Variance Petition No. 201403045

DEPARTMENT OF COMMUNITY DEVELOPMENT RECOMMENDATION

Variance Petition No. 201403117

Variance Petition No. 201403132

Parcel Map
Proposed Site Plan – Dated received August 29, 2014
Photographs

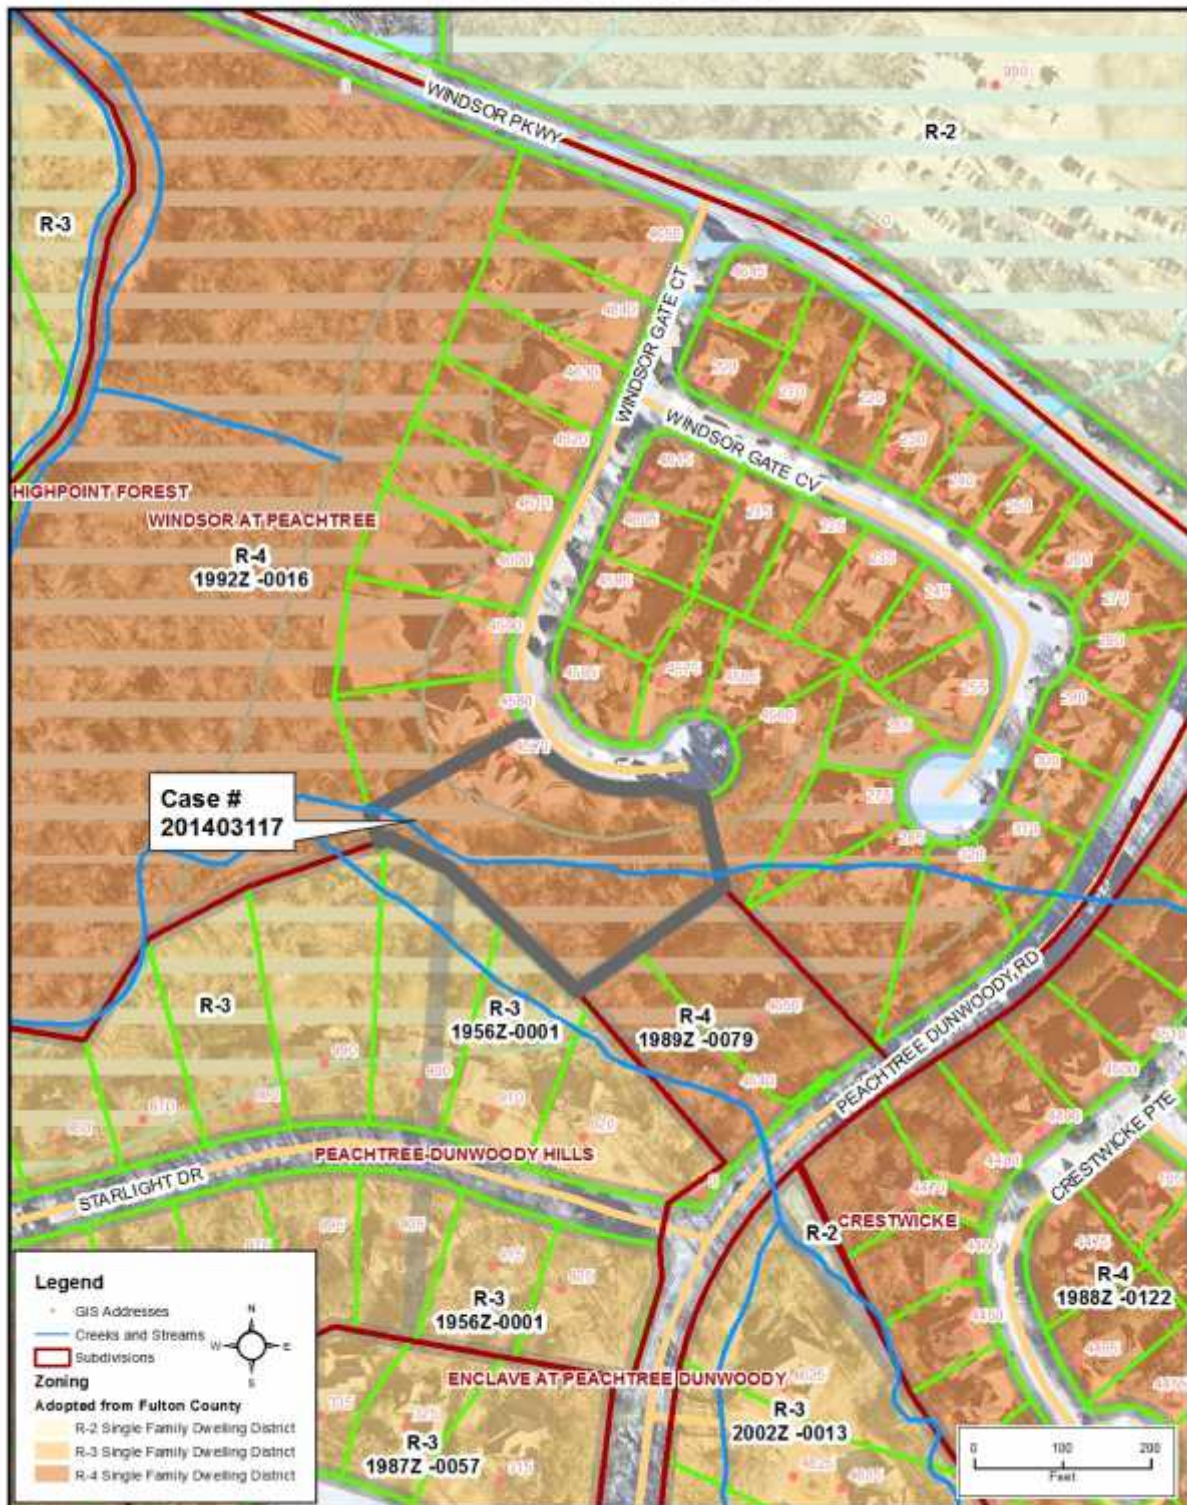
The location and extent of the stream buffer intrusions are identified on the attached site plan and are included in the table above. Staff is of the opinion this condition has been satisfied.

Alternative designs have not been discussed with staff. However, the applicant is proposing to locate the addition to the dwelling out of the twenty-five (25) foot state buffer and to reduce the existing encroachment into the fifty (50) foot undisturbed buffer by fifteen (15) feet. Encroachment into the seventy-five (75) foot stream impervious surface setback would be increased by two (2) feet. The addition has been designed to reduce the overall encroachment into the stream buffers. Therefore, staff is of the opinion this condition has been satisfied.

The proposed addition would not encroach into the twenty-five (25) foot state buffer and reduces the overall impervious encroachment by thirteen (13) feet. Staff is of the opinion that issuance of the variance is as protective of the natural resources and environment as the existing site conditions.

- 1) To allow an addition to the existing single family residence as shown within the site plan dated received August 29, 2014 by the Department of Community Development.

Proposed Site Plan – Dated received December 12, 2014

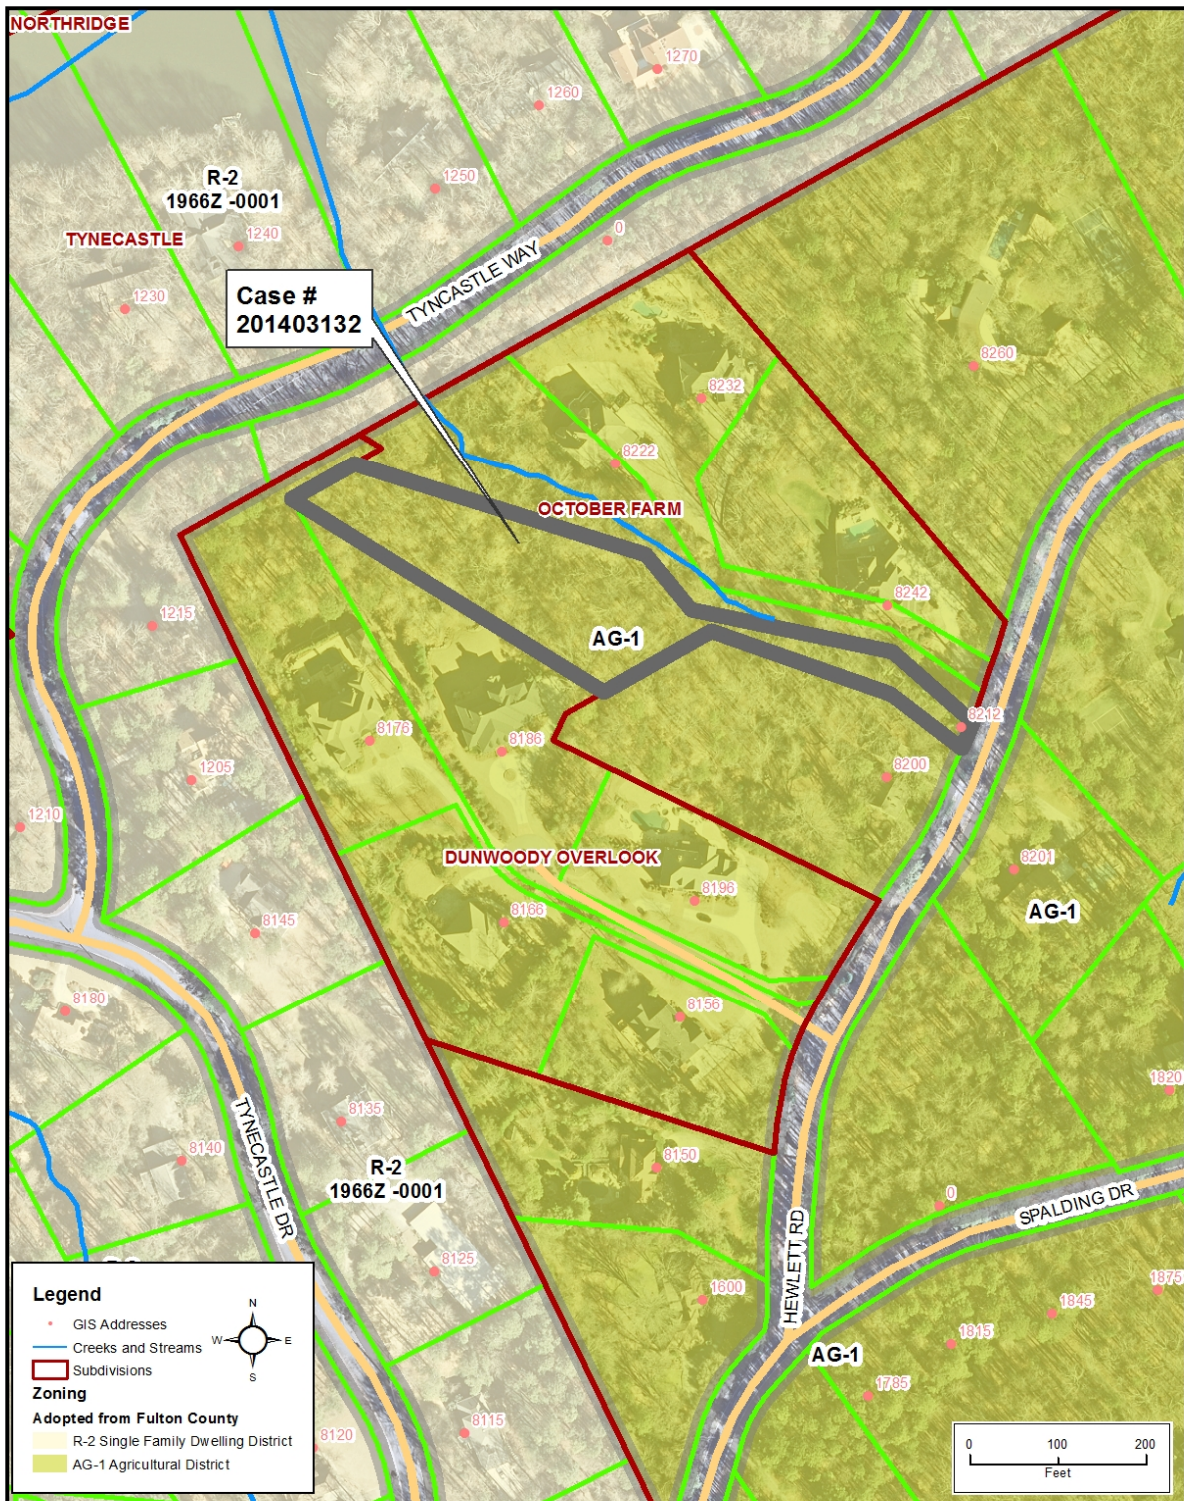
The location and extent of the stream buffer intrusions are identified on the attached site plan and are included in the table above. Staff is of the opinion this condition has been satisfied.

Following the November 2014 Board of Appeals meeting, alternative designs were discussed with staff. The construction of the home is now limited to encroachment within the 75 foot stream buffer as opposed to the previous site plan which included encroachment into the 50 foot undisturbed buffer. Therefore, staff is of the opinion this condition has been satisfied.

The applicant has modified the site plan for the home to now lie outside both the 25 foot and 50 foot undisturbed buffers. The applicant proposes using pervious surfaces for the driveway, **700 square feet of which encroach into the 75 impervious surface setback. Of the home's 2,600 first floor square footage, 1,100 square feet will still lie within the 75 foot impervious surface setback.** Staff believes the house could be moved toward the western property line, moving a large portion of its square footage outside of this setback. The floorplan and shape of the home could be modified to accommodate this as well. Staff is of the opinion that issuance of the variance is not as protective of the natural resources and environment as the existing site conditions.

- 1) To allow for construction of a single family residence as shown on the site plan dated received December 12, 2014 by the Department of Community Development with the exception the footprint of the home should not lie within the fifty (50) foot undisturbed buffer.
- 2) Pervious pavers shall be used on portions of the driveway lying within the 75 foot buffer impervious surface setback.
- 3) Allow for a 10 foot encroachment into the 50 foot undisturbed during construction to be replanted to buffer standards upon completion of construction.
- 4) Perform a siltation study on the lake prior to and after construction of the house.
- 5) Install turbidity fence subject to agreement submitted by the Lake Northridge Association.

Proposed Site Plan – Dated received September 2, 2014

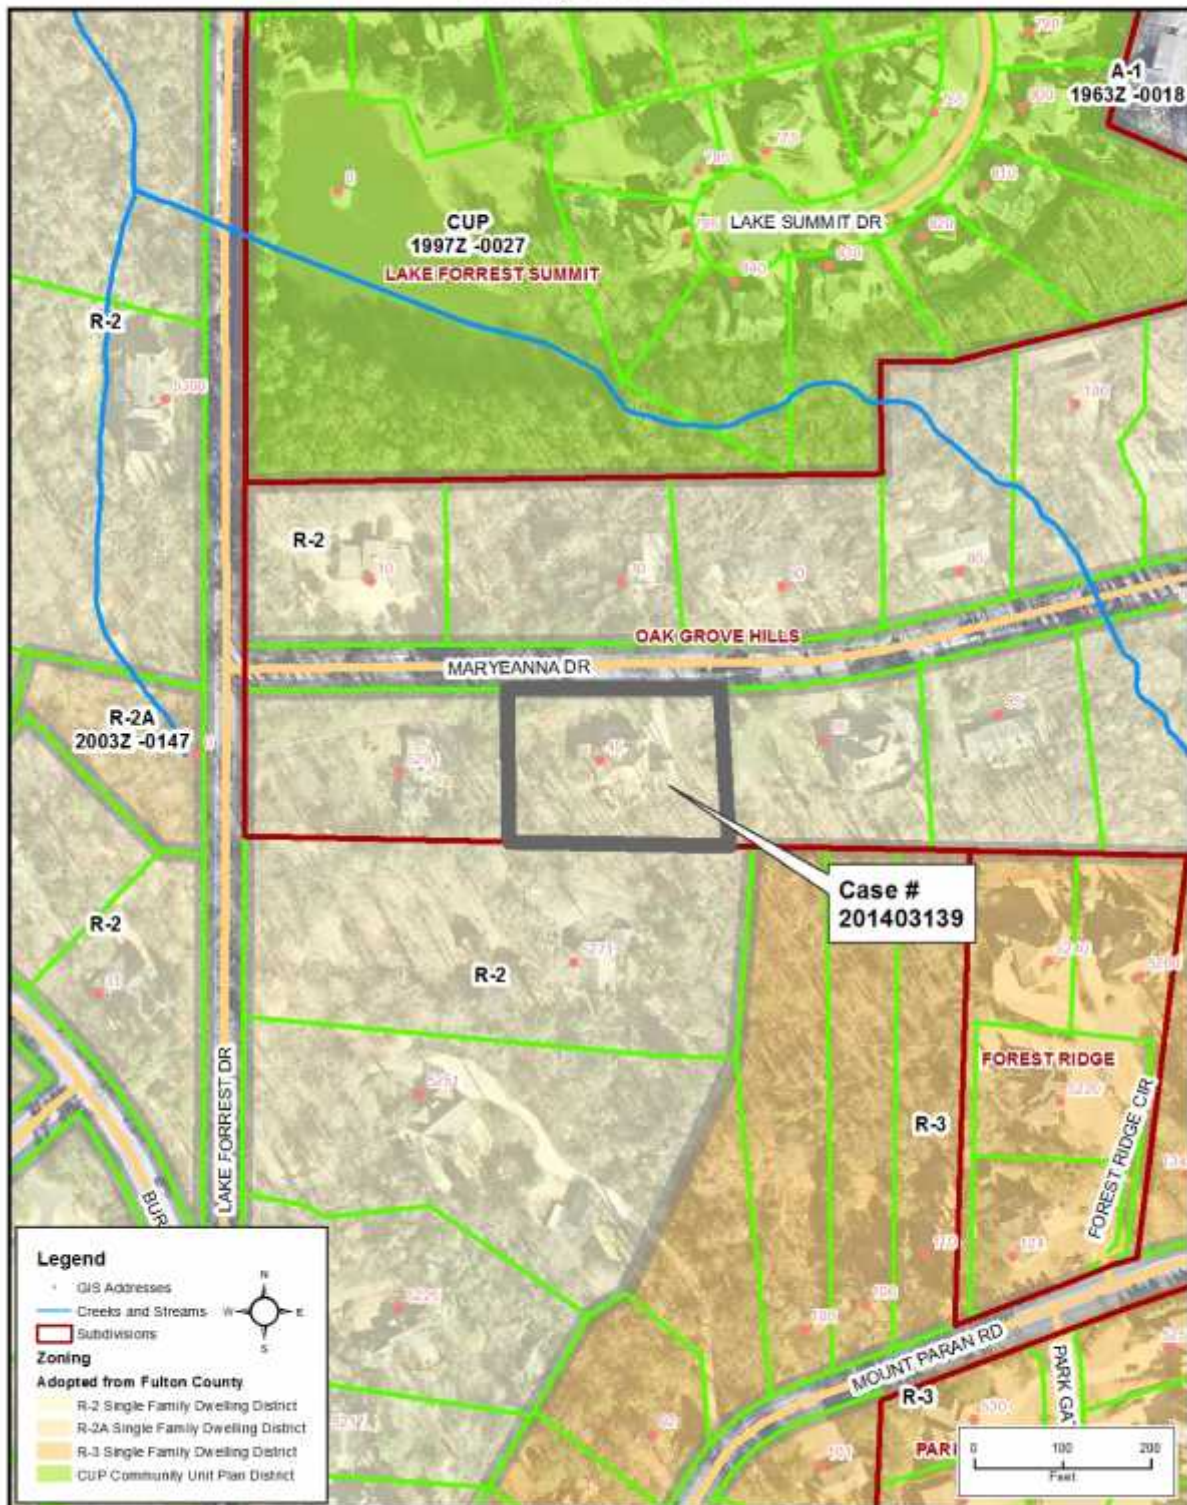
The intent of the Zoning Ordinance is to maintain the character and uniformity of the neighborhood. By right, an enclosed porch could encroach ten (10) feet into the rear minimum rear yard. The applicant would

request an additional eight (8) feet from this. Being the deck is located in the rear yard and the footprint would not be expanded, the impact on adjacent property owners would be minimal. Based on these considerations, staff is of the opinion that this condition has been satisfied.

The property's shape, topography, and physical conditions existed at the time of the adoption of the ordinance. The home on the property was constructed after the adoption of the ordinance. Based on these considerations, staff is of the opinion that this condition has not been satisfied.

- 1) To construct a roof over an existing porch within the minimum rear yard as shown on the site plan dated received September 2, 2014 by the Department of Community Development.
